Bulletin No: TSB-1184 **Date:** August 26, 2020

Models: 8AR / 8MR Series

Subject: Connector Change

Fig. 1

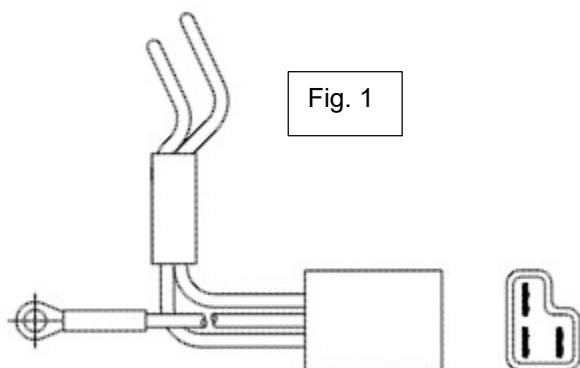
A connector change has been made from Fig. 1 to Fig. 2.

If your alternator utilizes the connector shown in Fig. 1 please follow the instructions below to convert the vehicle to the new connector.

Fig. 4

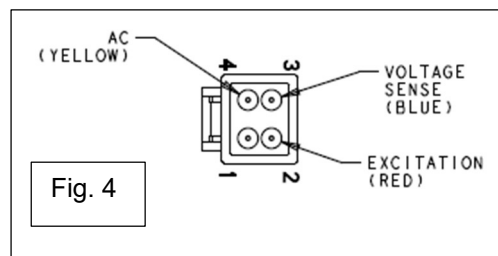
Use Fig.3 and Fig.4 to help identify the alternator wiring between the two connectors.

For this installation, the existing connector on the vehicle wiring harness must be removed and the new female connector (Fig. 5) spliced on to the harness. In case the vehicle harness wires are not color coded like the connectors in Fig.3 and Fig.4, care must be taken to label the vehicle harness wires so they may be spliced on to the correct color-coded wires on the new connector. Be sure to make harness connections based on the numbers molded on the plug of the new connector Fig 4. To protect the connections made to the vehicle harness from the environment, use a product such as heat shrink tubing.
